YARMOUTH
CUMBERLAND COUNTY
I-295 EXIT 15 (ROUTE 1)
IM-1108(600) EXIT 15
CM-1749(000)X PARK & RIDE LOT
WIN 11086.00 & 17490.00
PROJECT LENGTH: 0.670 MILES
INTERCHANGE IMPROVEMENTS AND PARK & RIDE

WIN 11086.00
WIN 17490.00
WIN 20258.00 Mod. #9
IM-1108(600) EXIT 15
CM-1749(000)X PARK & RIDE LOT
As-Built by T&D Dec. 2013

TITLE SHEET

NORTHBOUND OFF RAMP
STA. 114+00 TO STA. 119+00
NOT TO SCALE

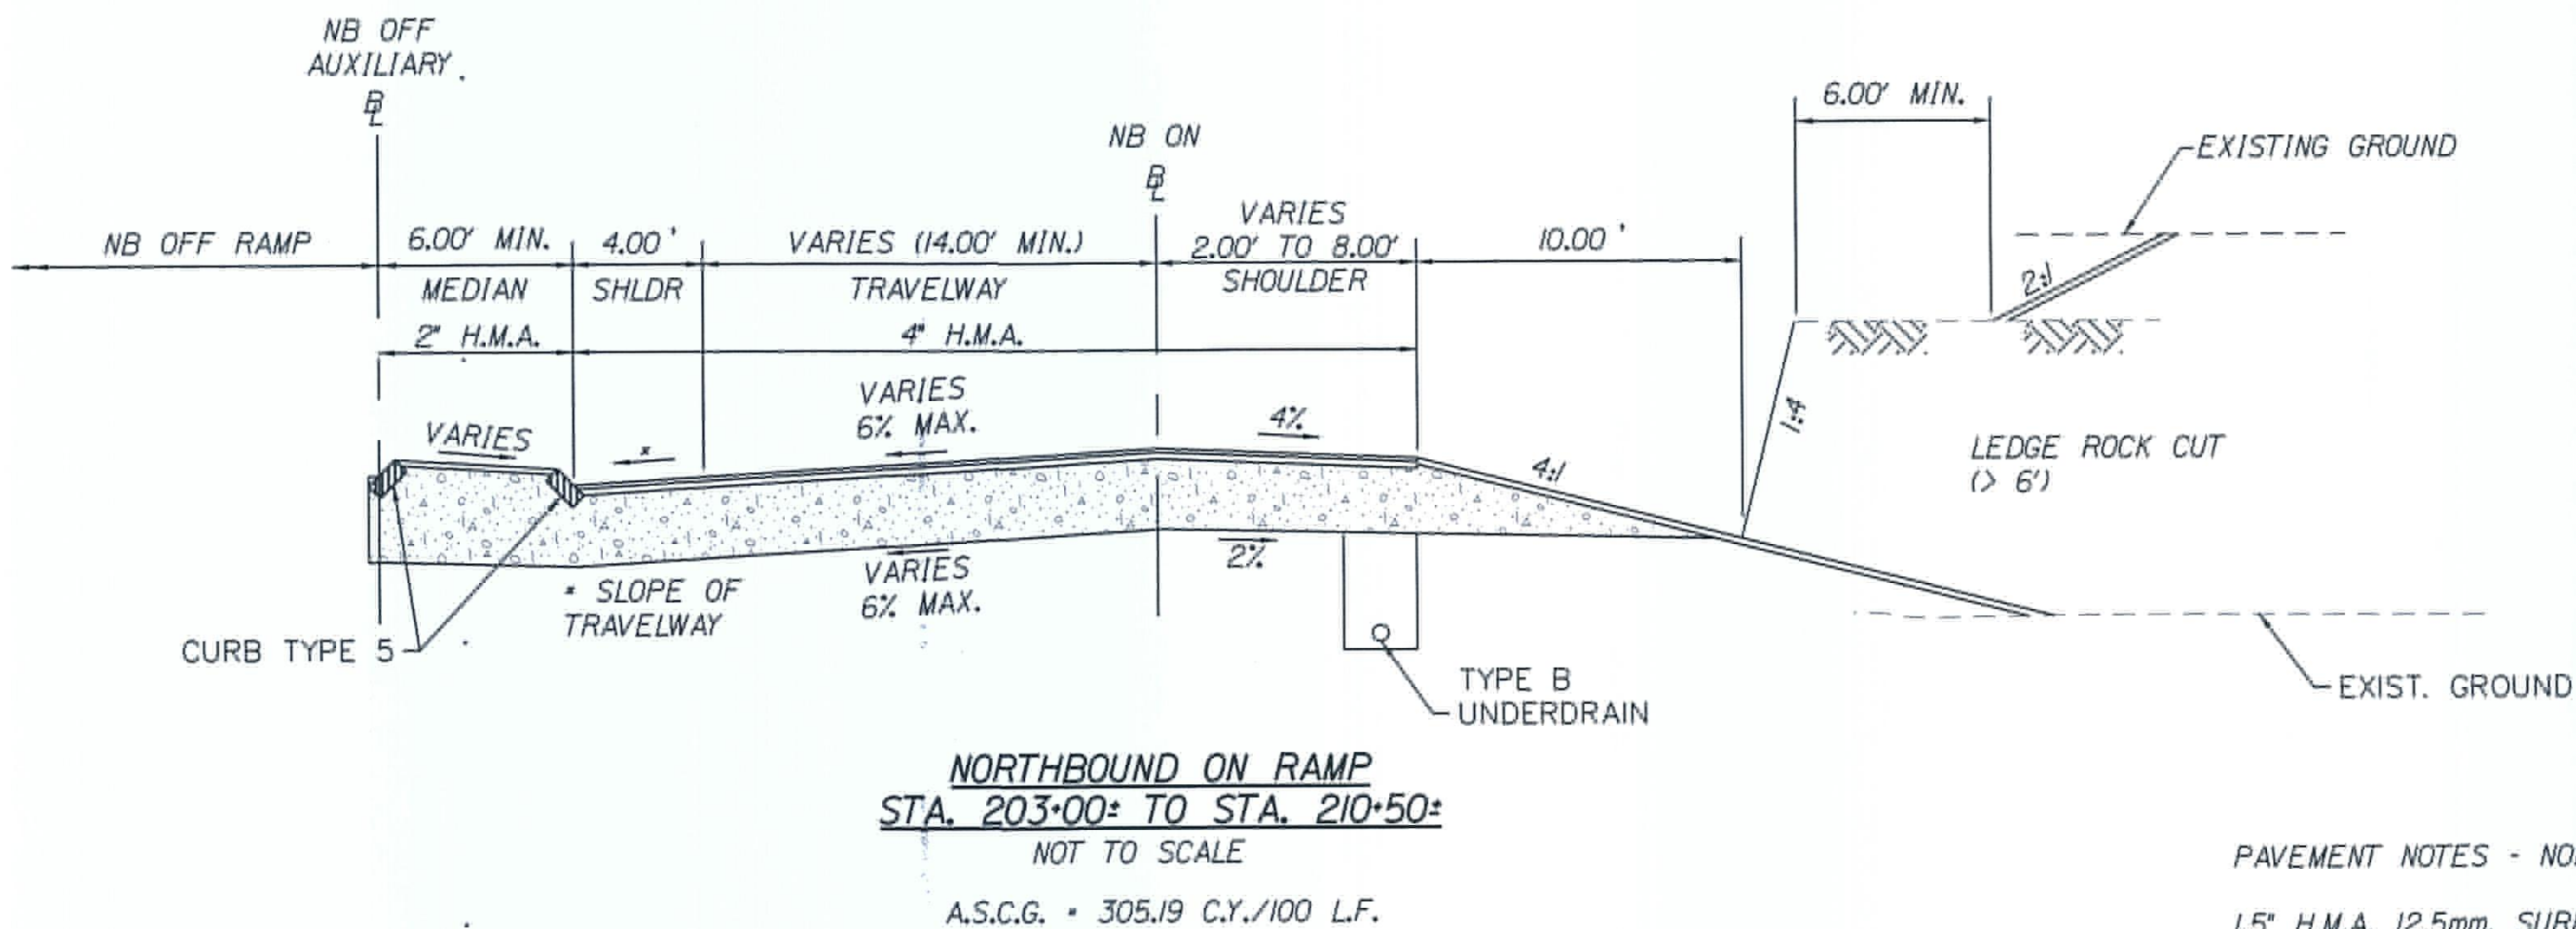
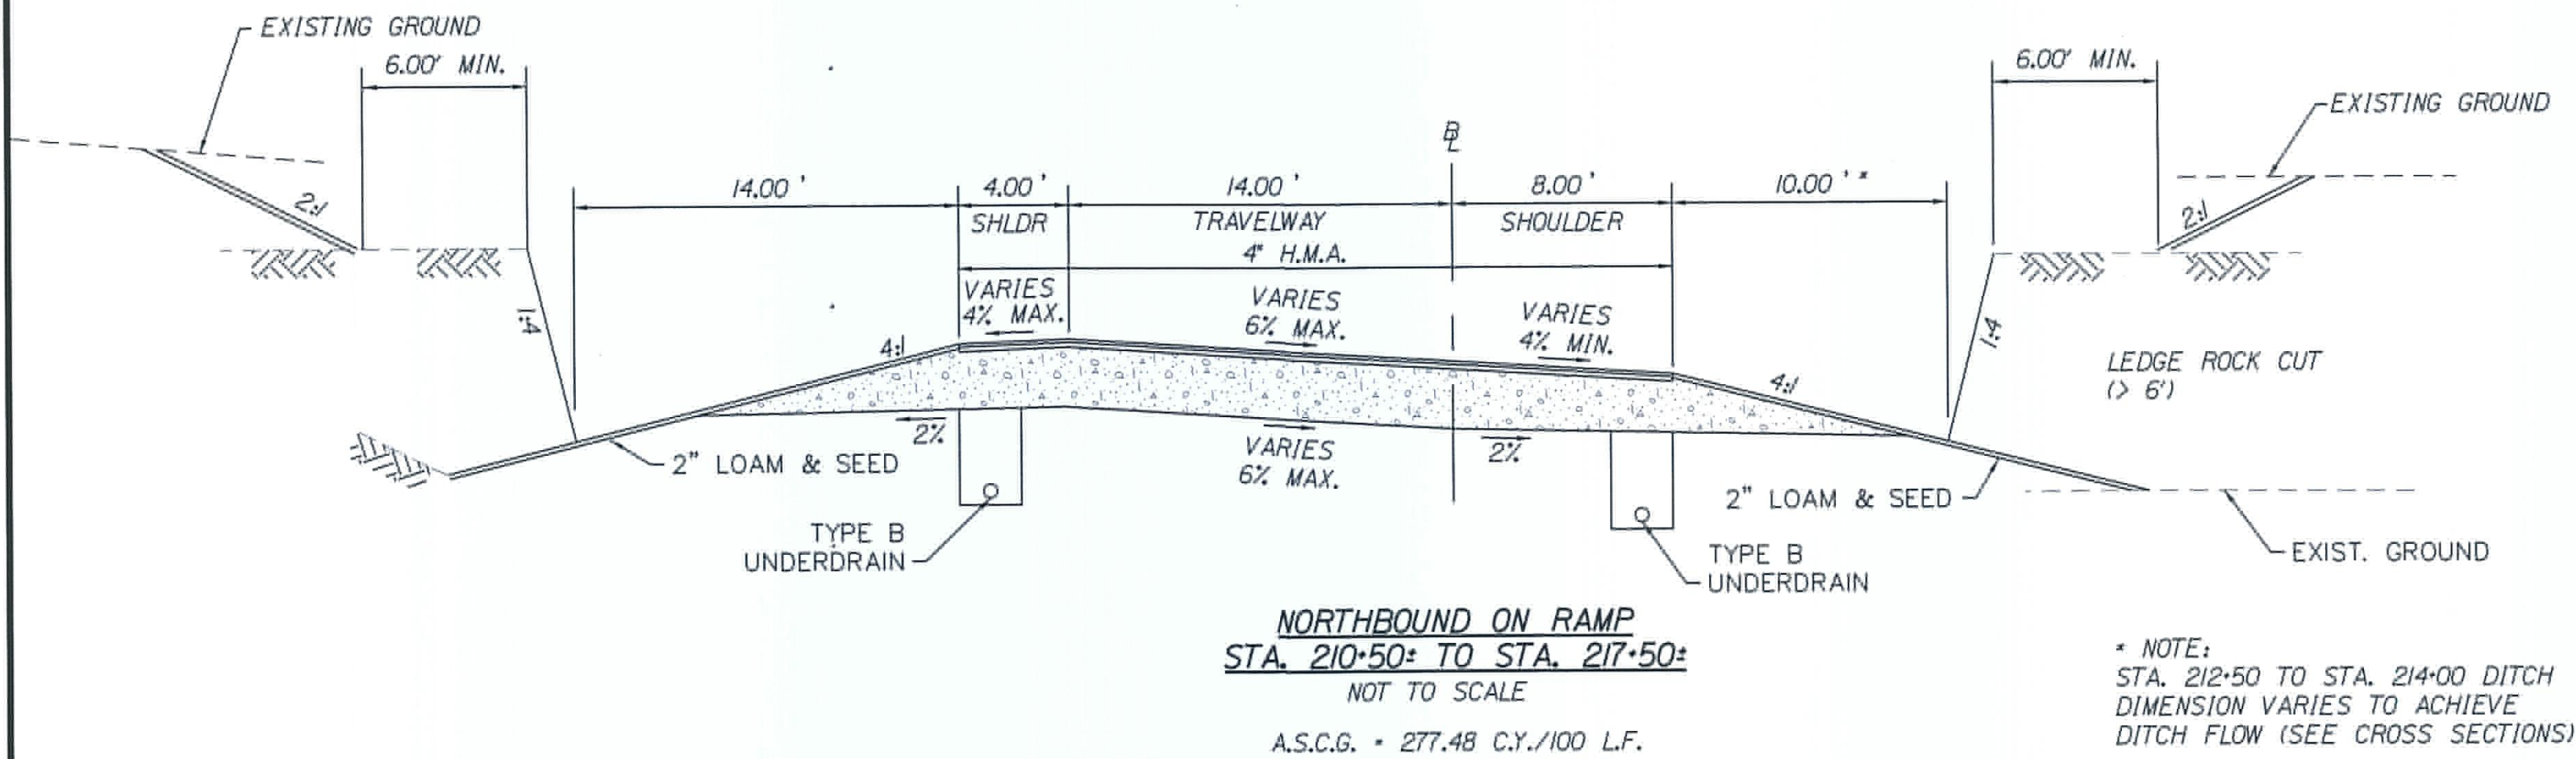
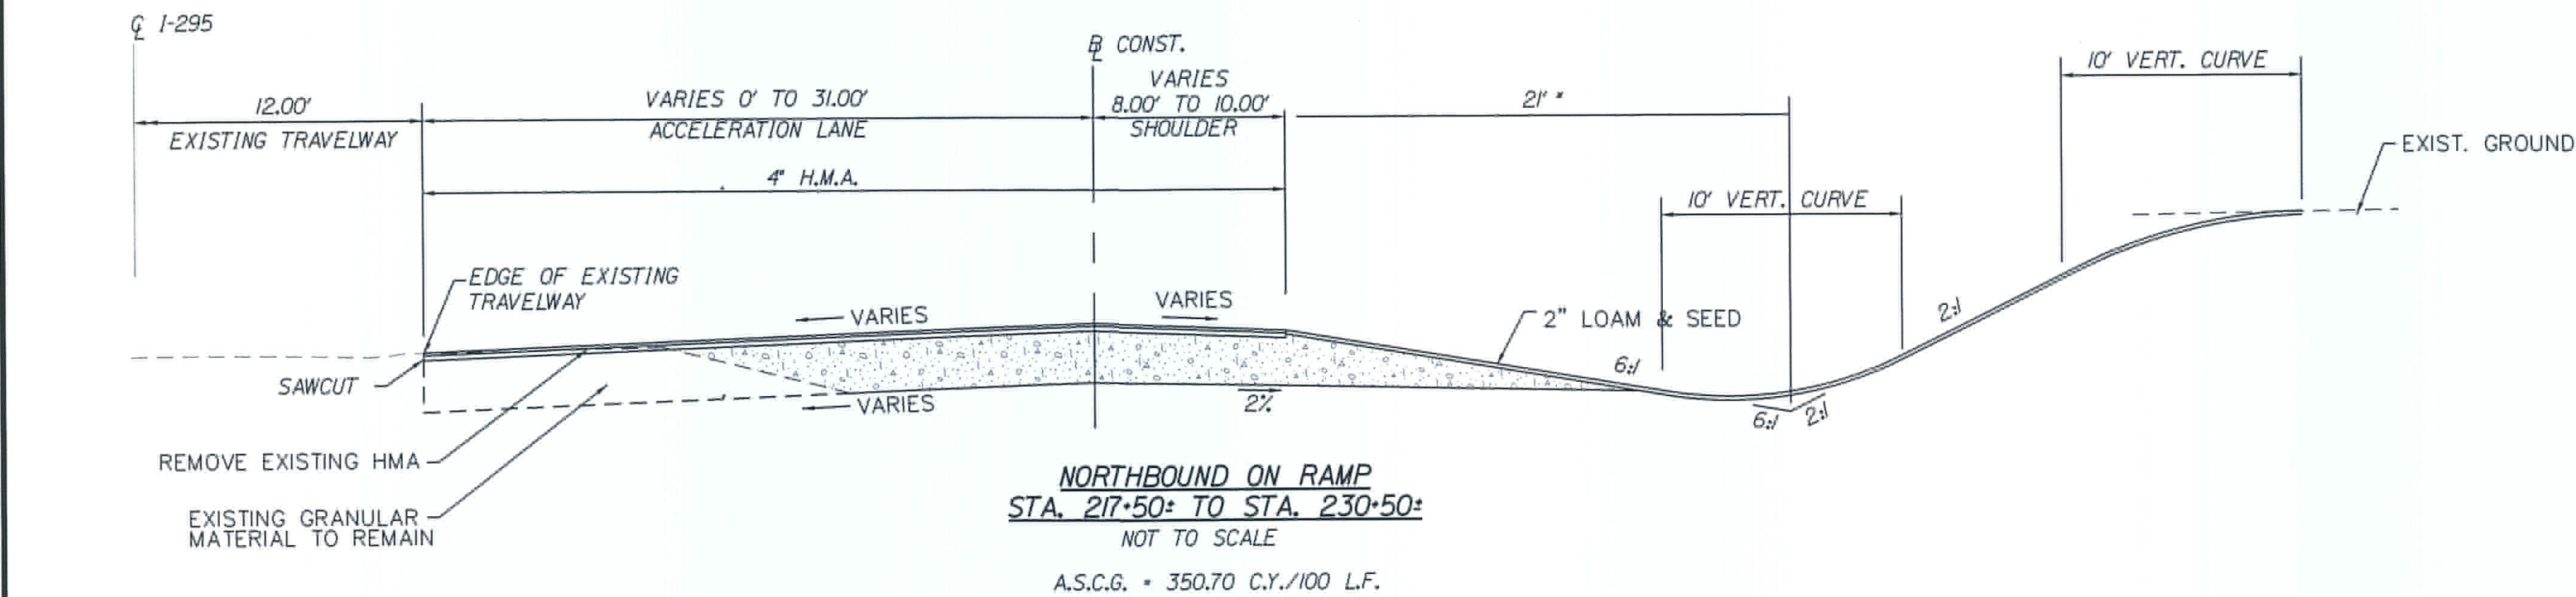
NOTES: 114+00
1. STA. 113+50 TO STA 124+50: ADD *open Graded Friction* ULTRA THIN BONDED WEARING COURSE TO TOP SURFACE

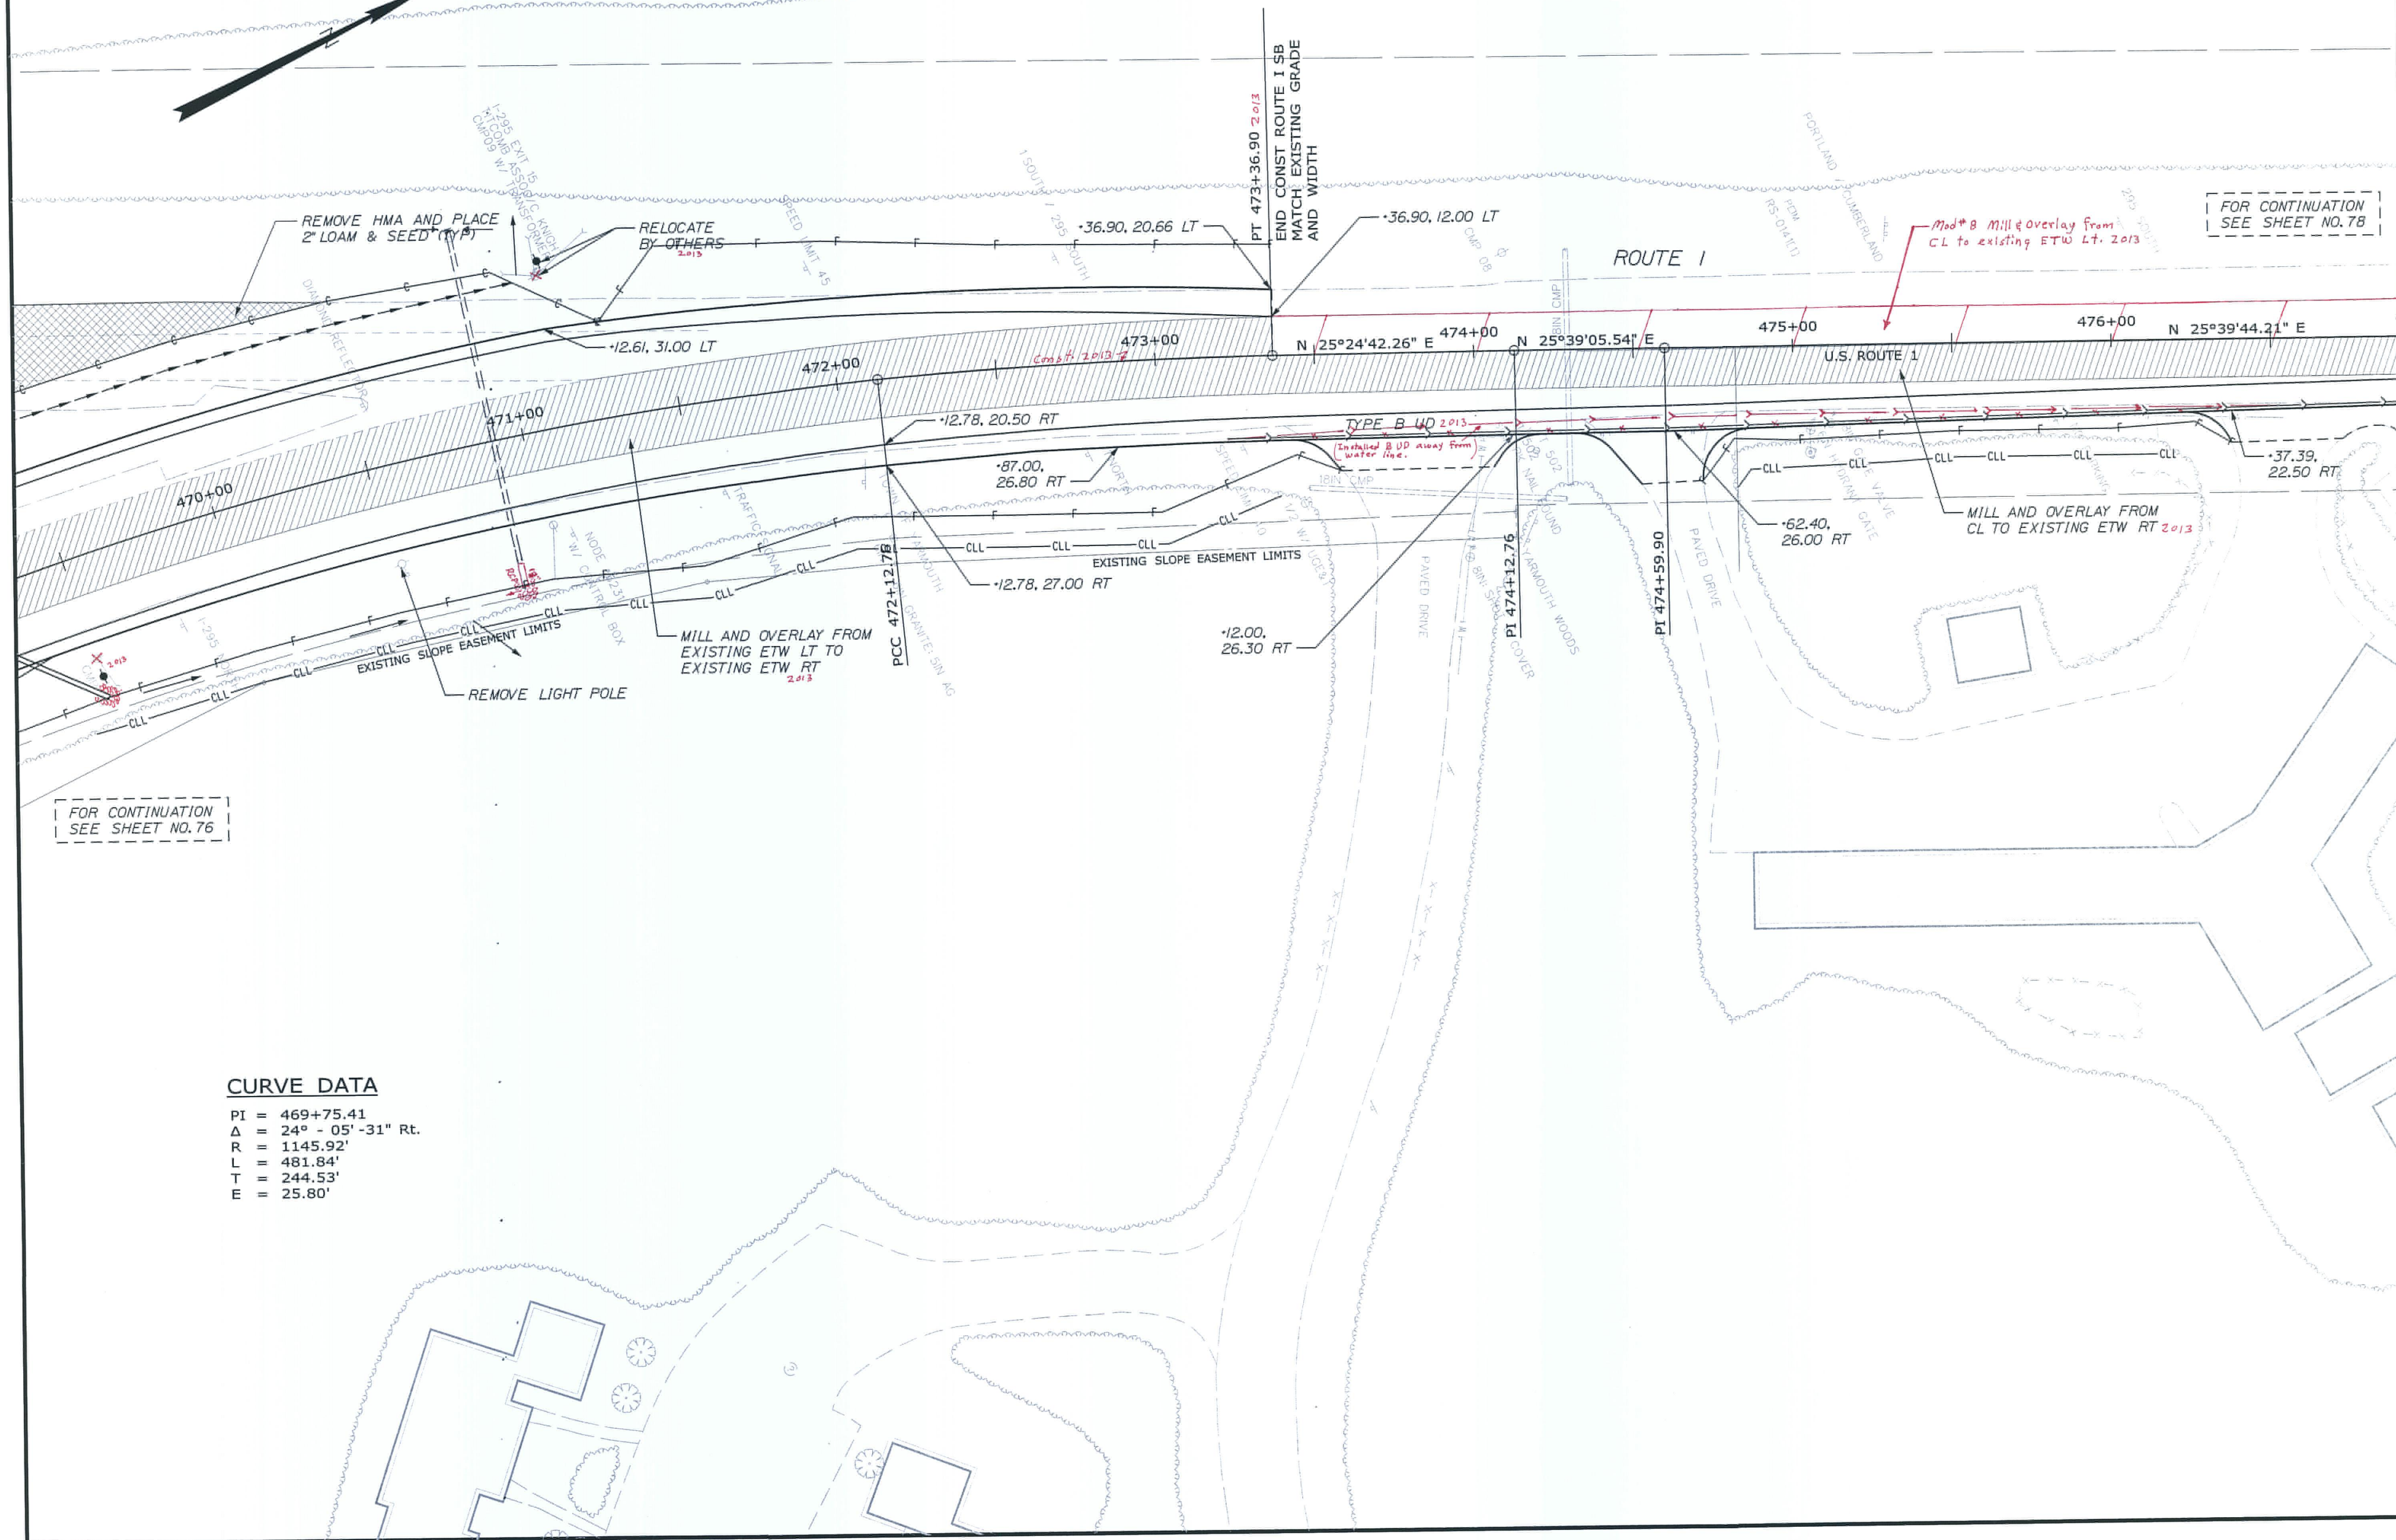
REMOVE HMA AND PLACE
2" LOAM & SEED (TYP)
— Planted Trees in area 2013 —
